## **PERMANENT AVIATION FUEL FACILITY**

### **FURTHER INFORMATION**

Per Clause 8(1) of the Environmental Impact Assessment Ordinance, Environmental Protection Department (EPD) has asked Airport Authority for further information, most of which was presented to the Advisory Council on the Environment prior to its meeting of 19 April 2007.

Airport Authority Hong Kong  
2 May 2007

**Figure 1: Comparison of EIA and HSL Total Societal Risk Estimates for PAFF<sup>4</sup>**

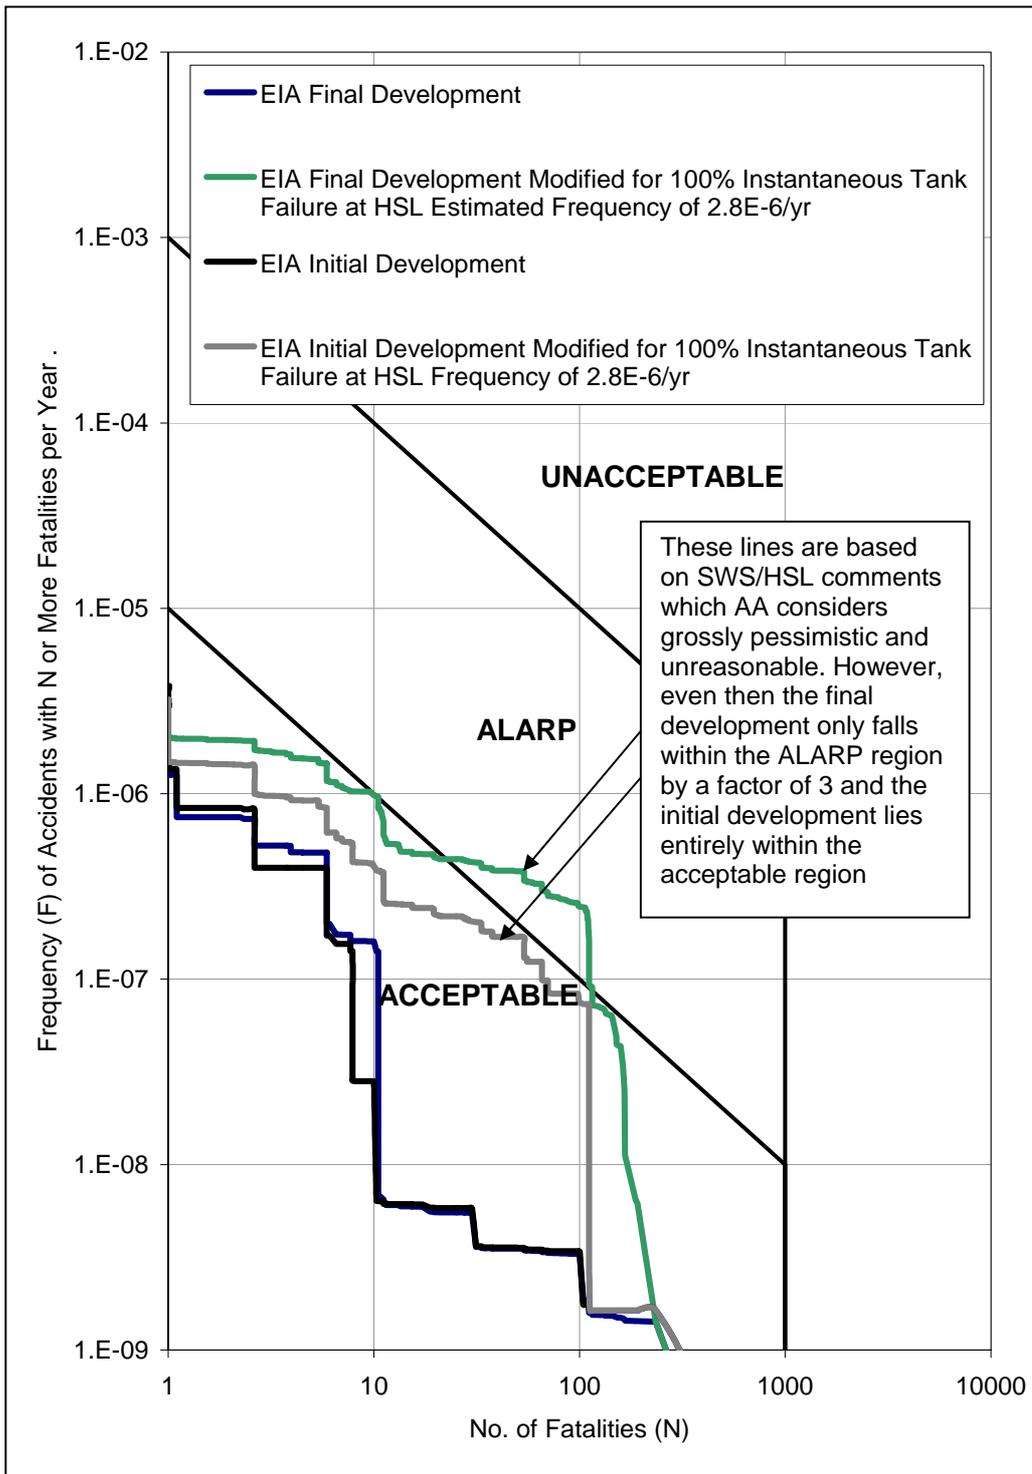
For the sake of argument, even if HSL’s 100% instantaneous tank failure frequency of  $2.8 \times 10^{-6}$  /yr is used (Figure 1), the Initial Development is completely acceptable and the Final Development (beyond year 2025) is also acceptable, providing the risks for the Final Development are kept As Low As Reasonably Practicable<sup>4</sup>. In fact, using the SWS/HSL assessment (which AA considers grossly pessimistic and unreasonable) the final development still only falls within the ALARP region by a factor of 3.

<sup>4</sup> Based on using HSL’s predicted “catastrophic” tank failure frequency of  $2.8 \times 10^{-6}$  /yr to apply to “100% instantaneous” tank failure instead of the EIA figure of  $5 \times 10^{-9}$  /yr specifically for 100% instantaneous failure of a PAFF tank. HSL [7] also suggest an even higher failure frequency based on a grossly pessimistic assessment of seismic risk, which is not included in Figure 1.

**Figure 2: Comparison of EIA and HSL Societal Risk Estimates For Initial PAFF Development**

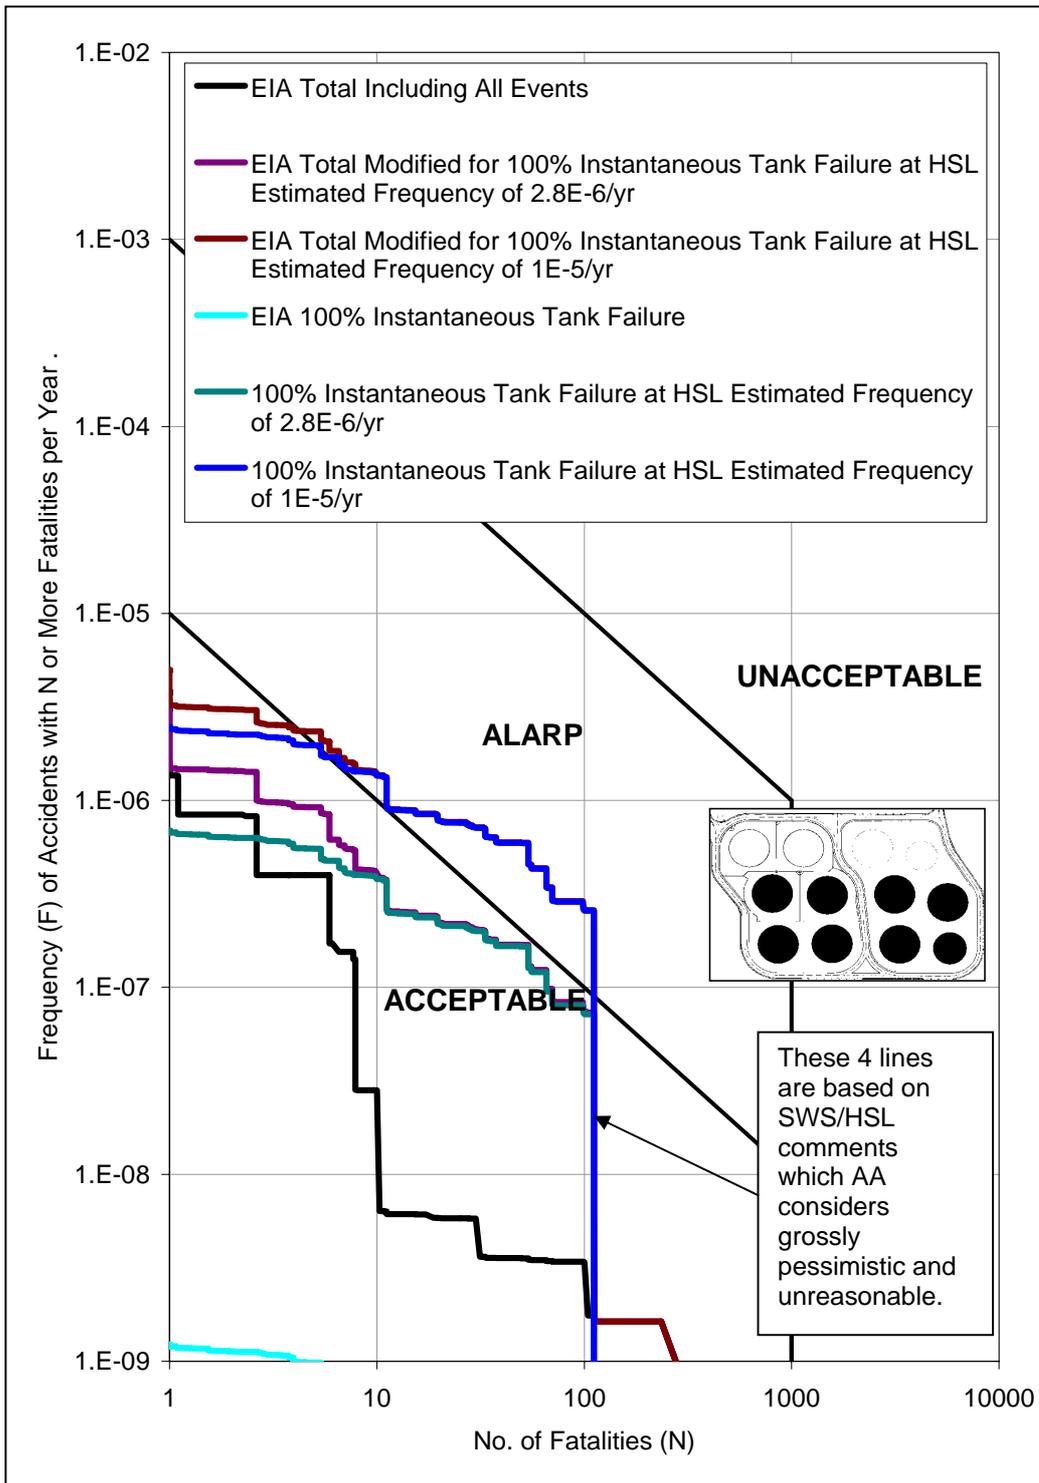
Figure 2 shows a comparison of the results from the EIA with those modified for HSL's [7] suggested 100% instantaneous tank failure frequencies for the Initial Development (8 tanks) and

As a result, HSL [7] suggest two failure frequencies for a PAFF tank. The first is based on their analysis of the data, as discussed above, and concludes that a frequency of  $2.8 \times 10^{-6}$  /yr is appropriate. This may be compared with a frequency of  $5 \times 10^{-9}$  /yr in the EIA report, derived specifically for the PAFF tanks. The second figure of  $1 \times 10^{-5}$  /yr is based on including a grossly pessimistic assessment of the 100% instantaneous failure frequency due to earthquake, as discussed in Section 2.1.5.

**Figure 3: Comparison of EIA and HSL Societal Risk Estimates For Final PAFF Development**

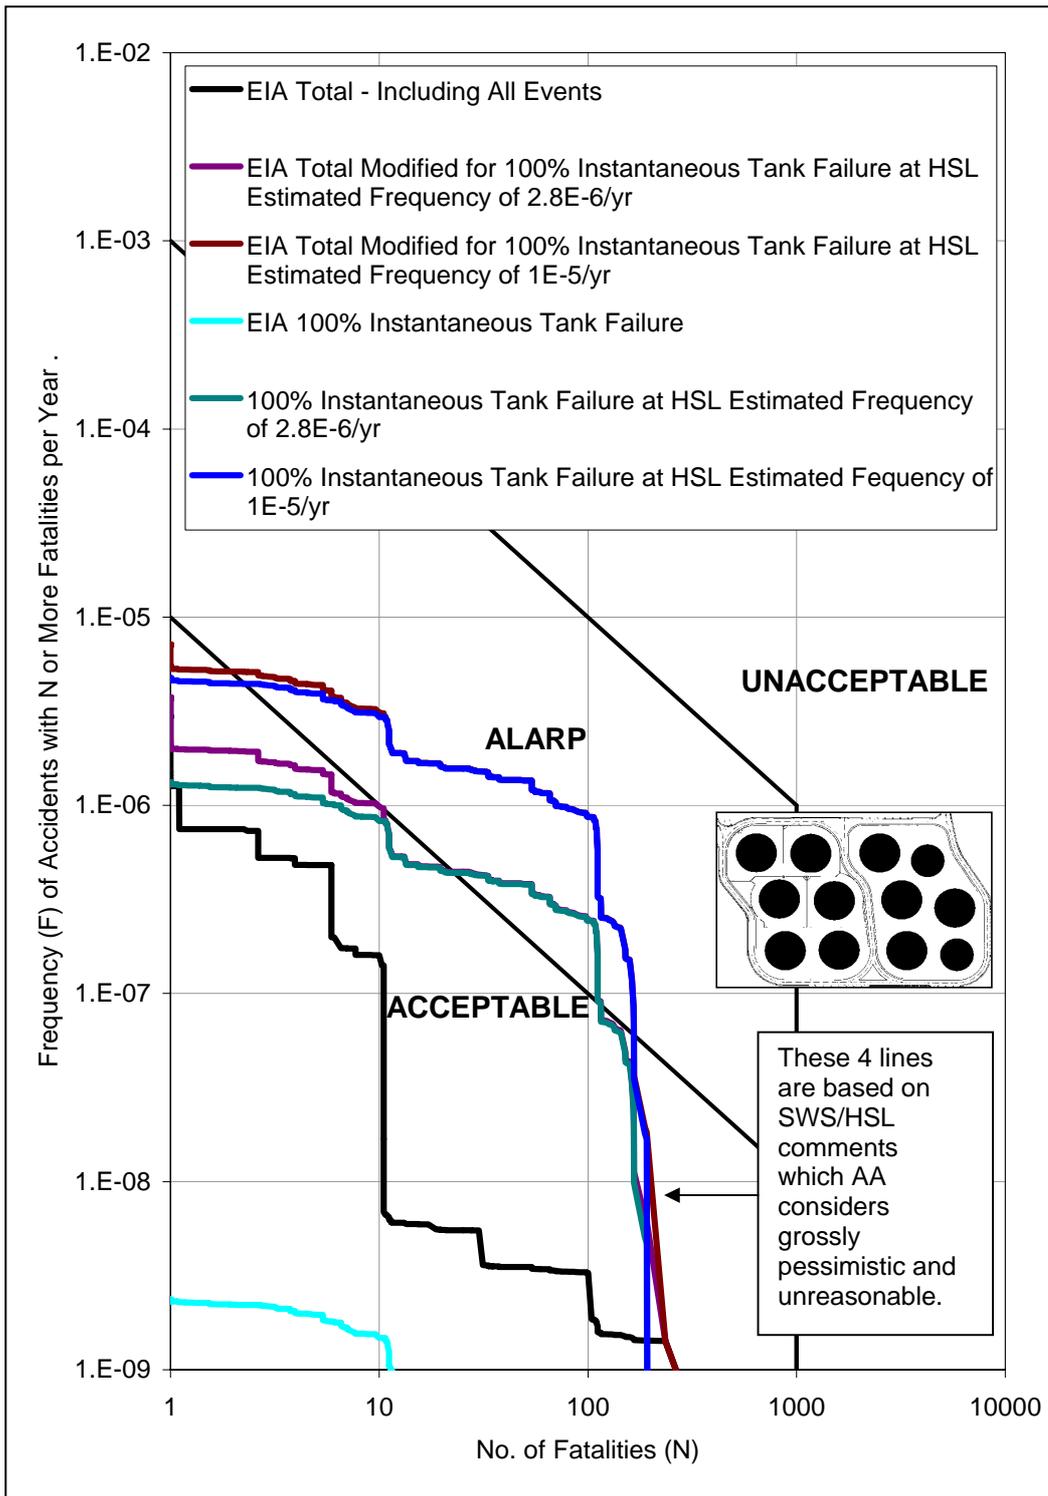
Figure 3 shows the same information for the Final Development (12 tanks). The basis is the same as shown in HSL's comments [7]
